ADDENDUM No. 5 – February 16, 2022

PART 1 - GENERAL

18 HS-11 Accordion Folding Door Striker Jamb Detail
 A10.6 SCALE: 1 1/2" = 1'-0"

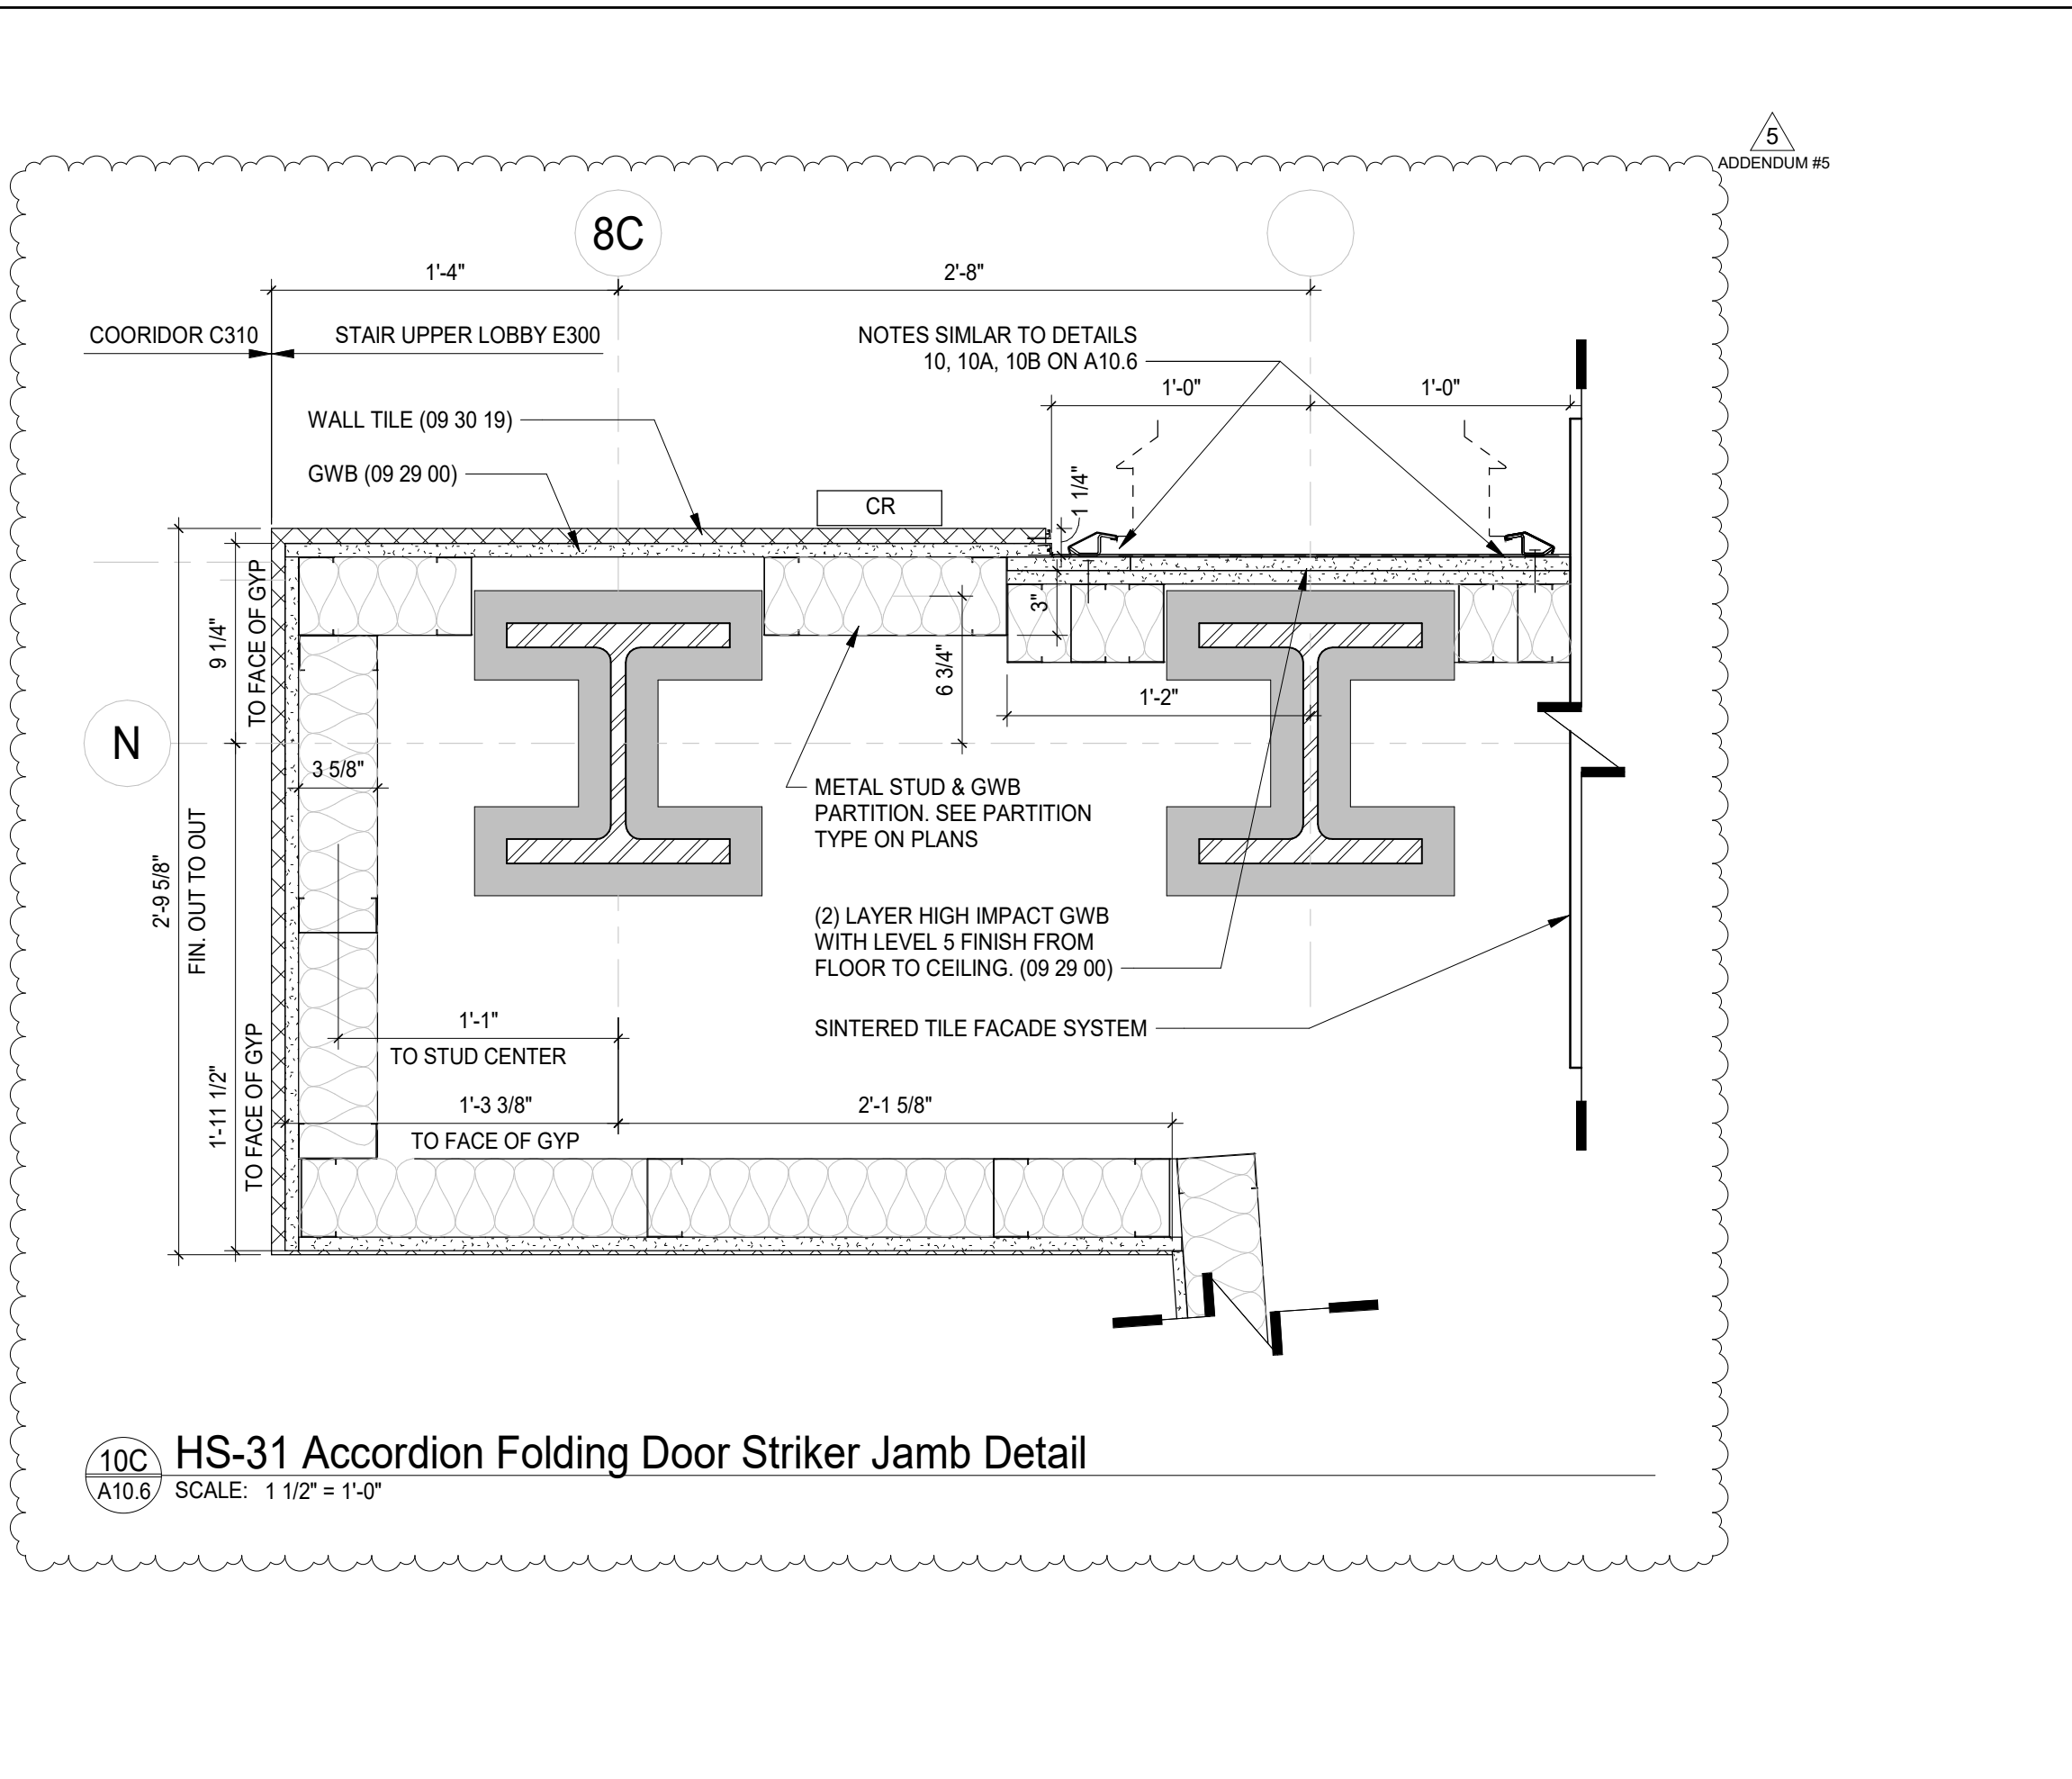
- A. At details 3, 4, 5 delete note "LIMIT OF TERRAZZO FLOORING"
- B. At detail 10, remove and replace with revised detail, see ADD-5/A-081
- C. At detail 18, remove and replace with revised detail, see ADD-5/A-081
- D. Insert new detail 10A HS-23 Accordion Folding Door Striker Jamb Detail, see ADD-5/A-082
- E. Insert new detail 10B HS-30 Accordion Folding Door Striker Jamb Detail, see ADD-5/A-083
- F. Insert new detail 10C HS-31 Accordion Folding Door Striker Jamb Detail, see ADD-5/A-083

1 Rolling Counter Shutter Jamb Detail
A10.4 SCALE: 1 1/2" = 1'-0"

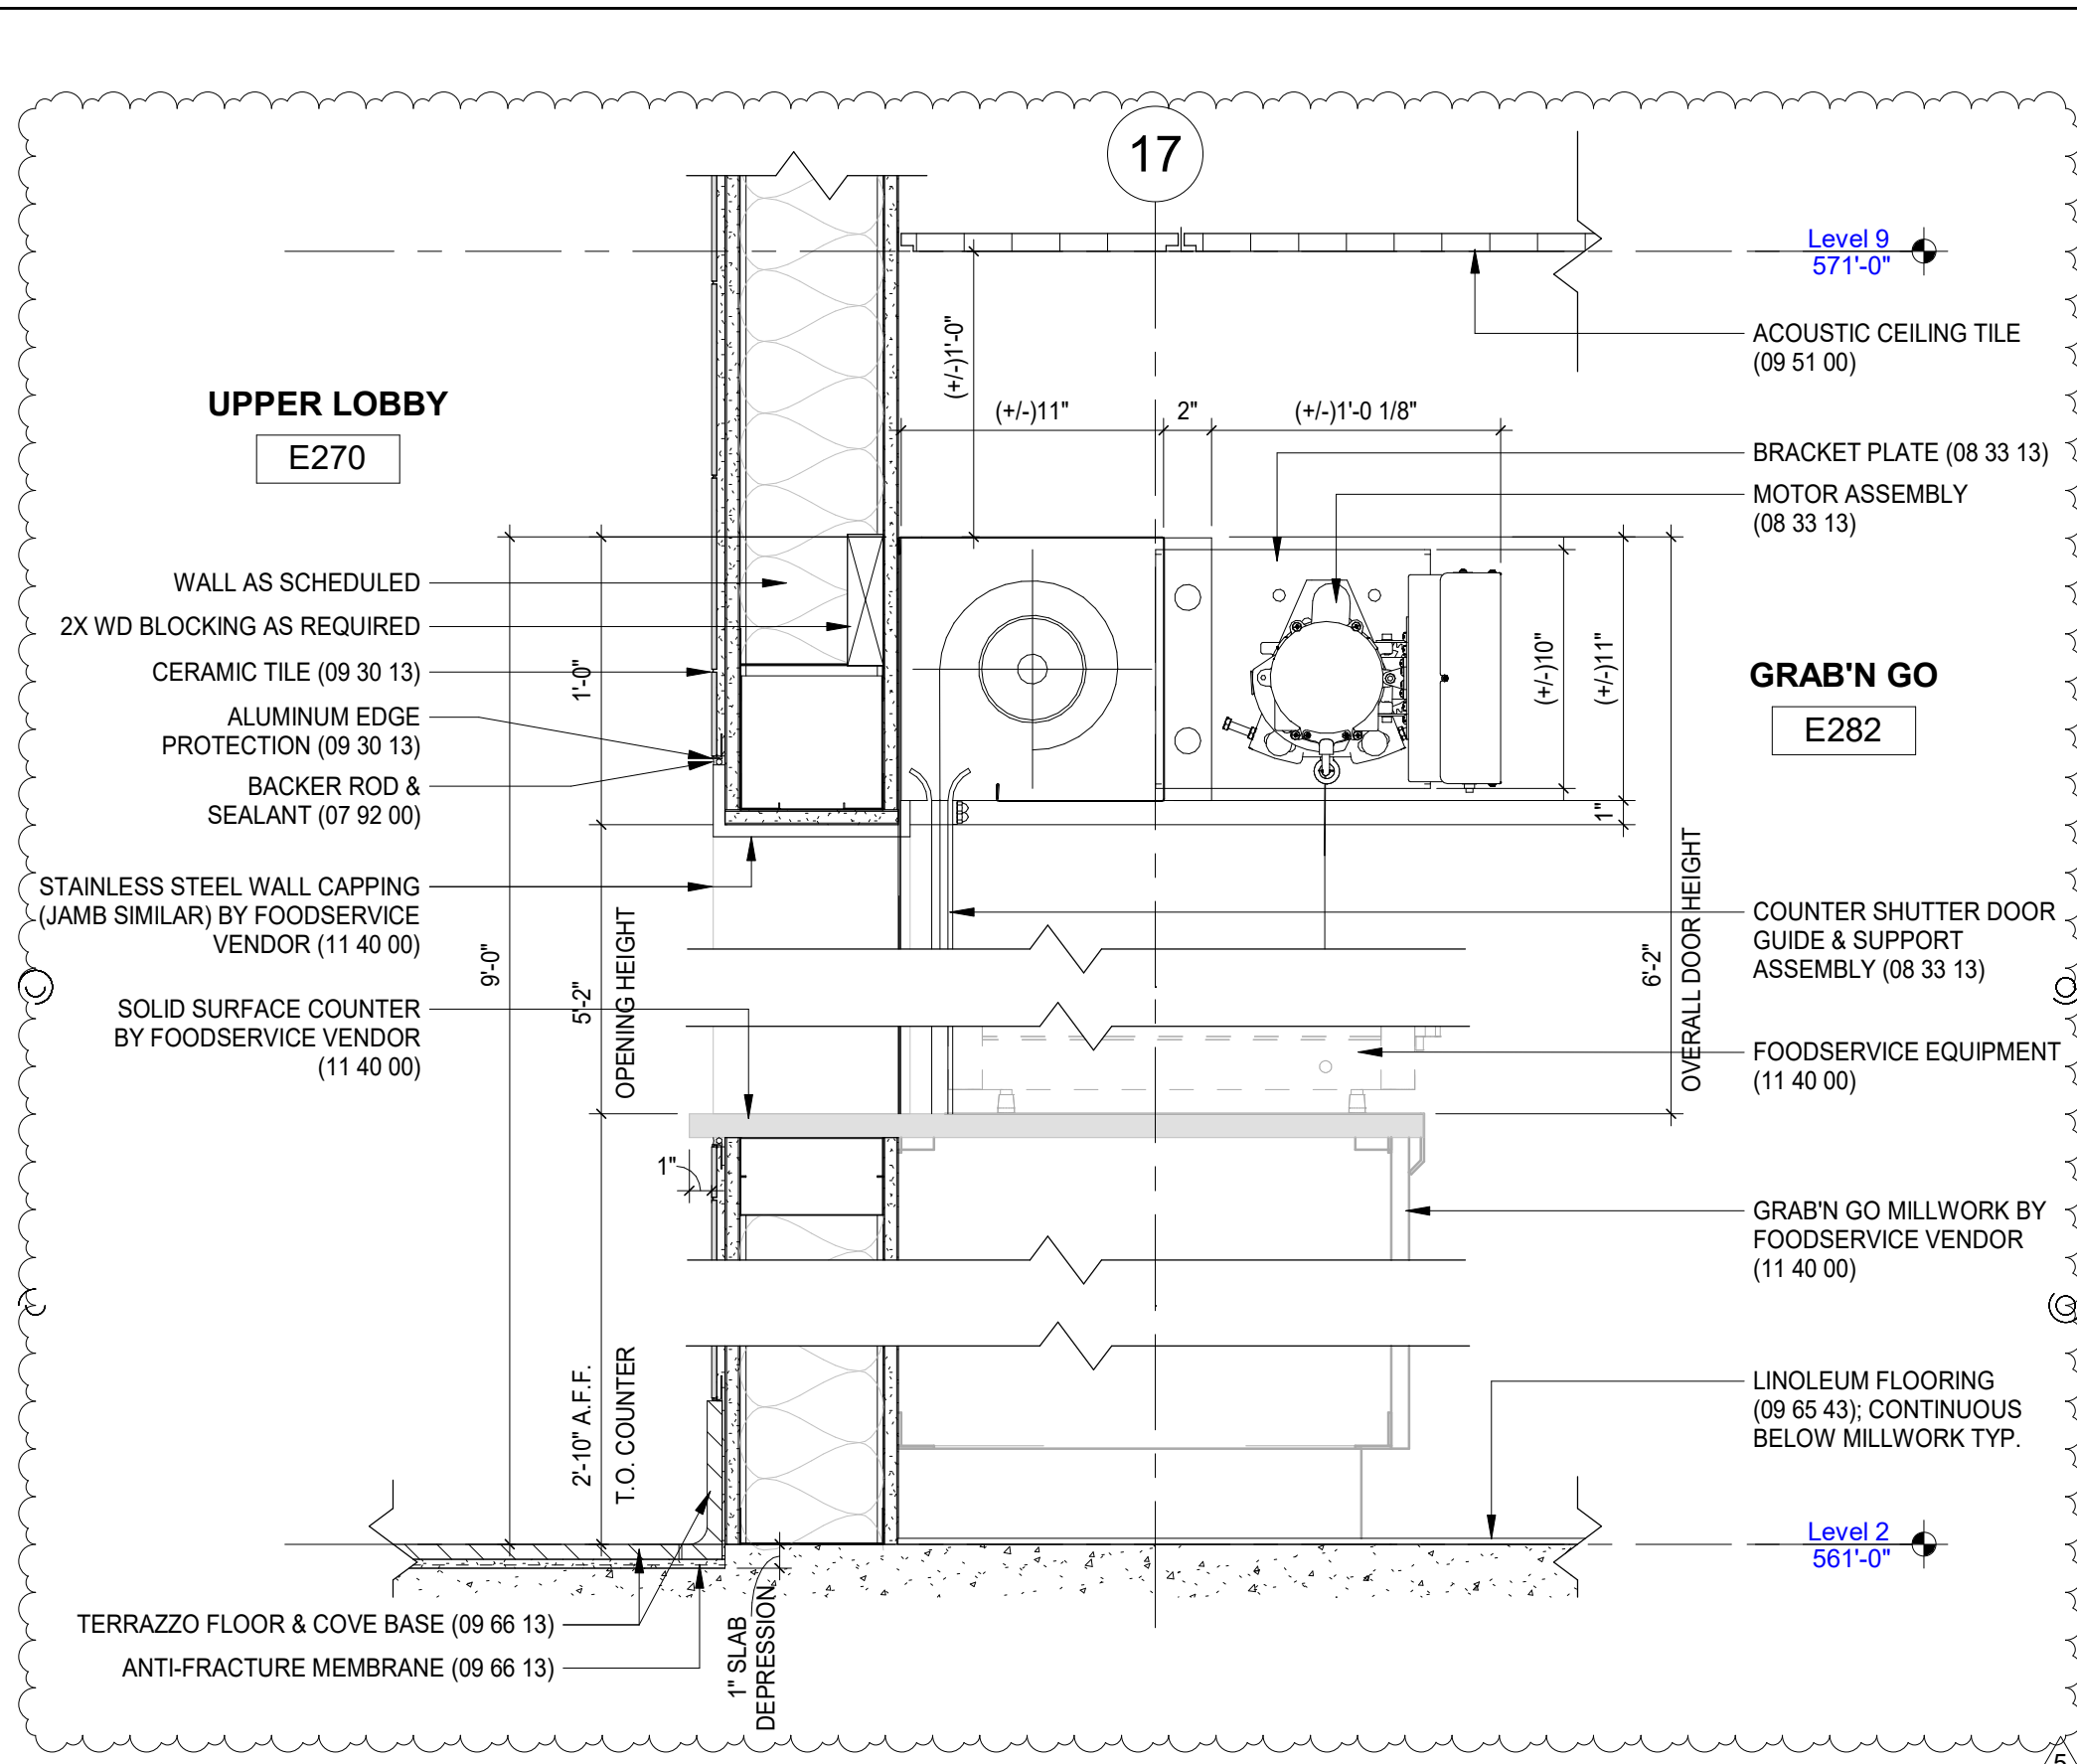
- A. Detail 1: Delete "STAINLESS STEEL COUNTER BY FOOD SERVICE" and insert "SOLID SURFACE COUNTER BY FOODSERVICE VENDOR" in its place; minimum

- dimension at operable side of jamb updated from 4-7/8" to 5"; add general annotation and dimensions
- a. Refer to sketch ADD-5/A-084
- B. Detail 2: Annotated and dimensioned
- a. Refer to sketch ADD-5/A-085
- C. In "DOOR SCHEDULE – FIFTH FLOOR SECTION D", delete Door D519.1.

8 Awning Detail
A3.18a Scale 1" = 1'-0"

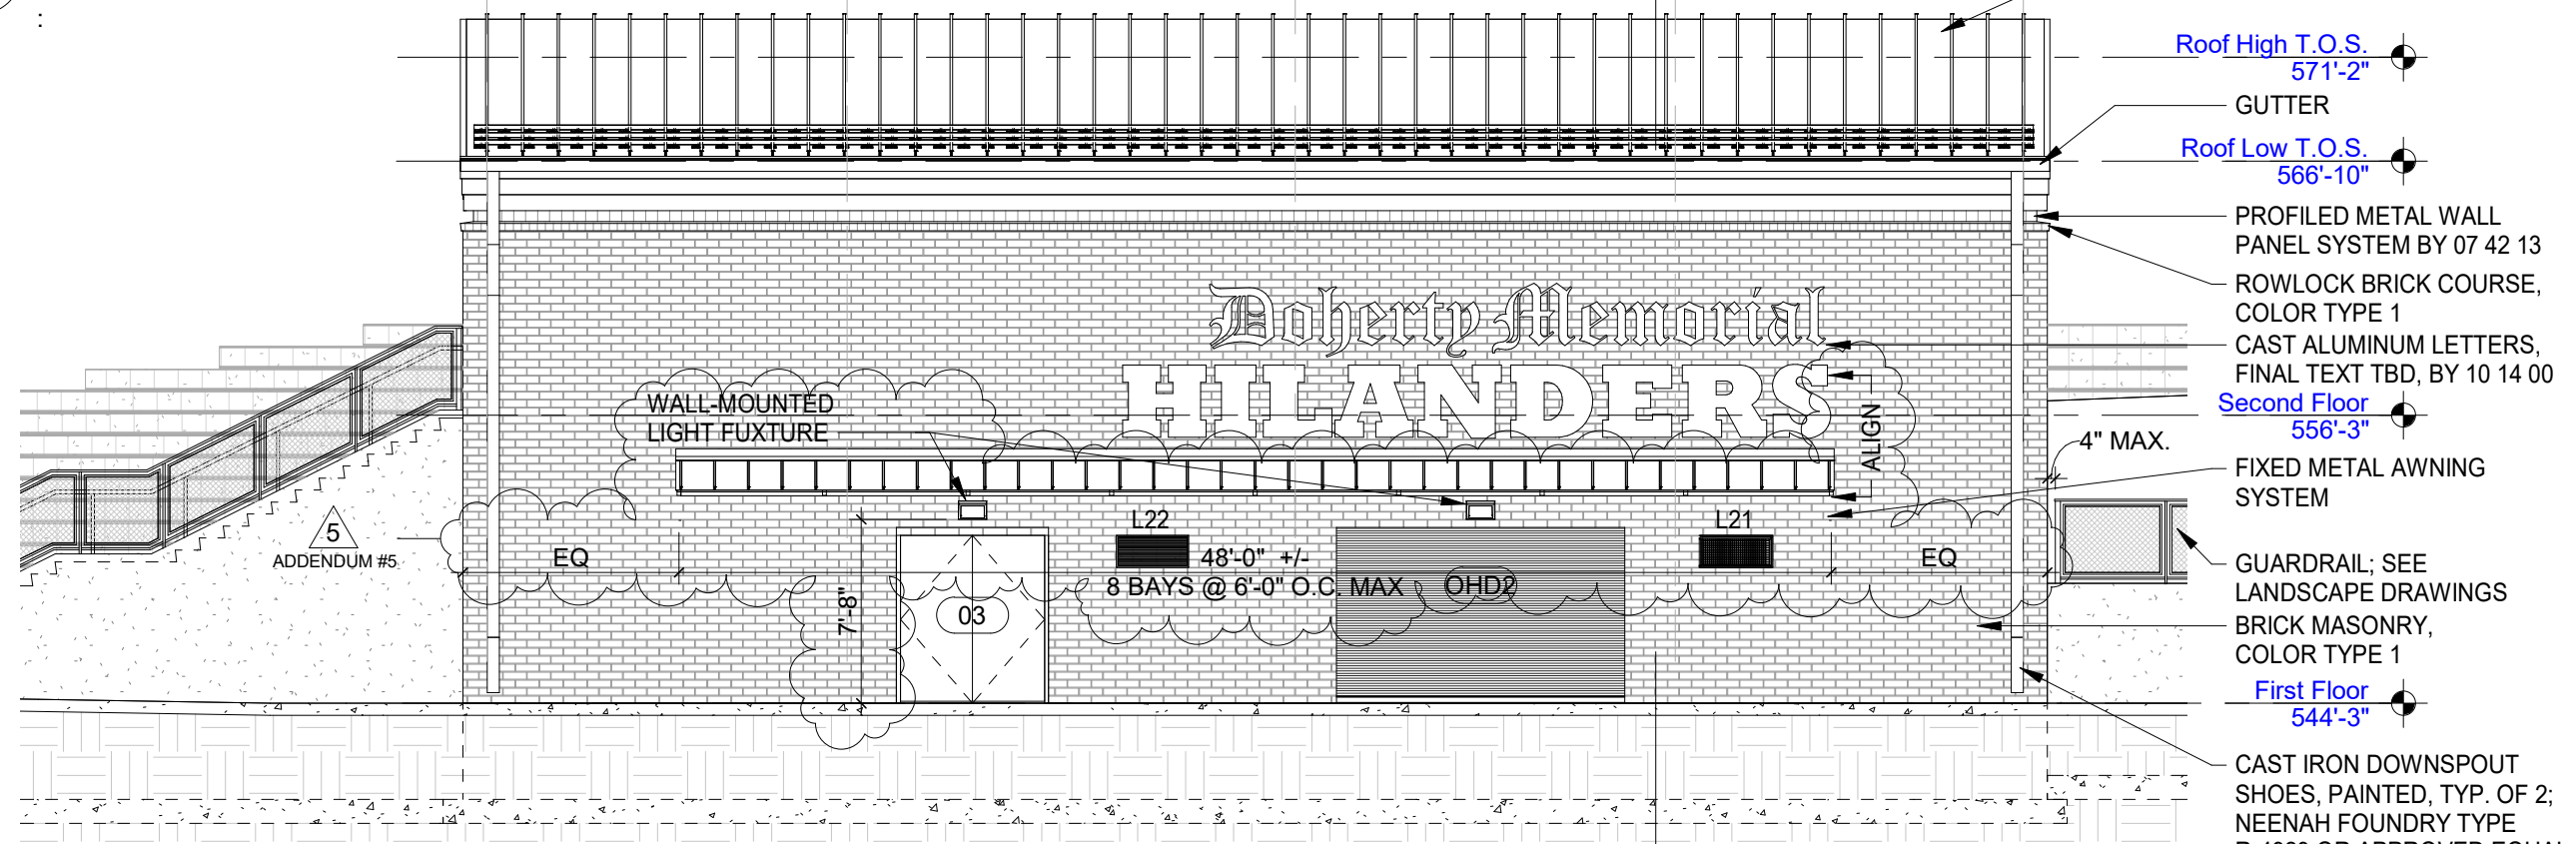
- F. At Detail 4, locate exterior wall-mounted lights above Doors 11 and OHD3, at 8'-6" above grade.
- G. Replace Detail 8 with new Detail 8; refer to sketch ADD-5/A-088 and conformed set of drawings.
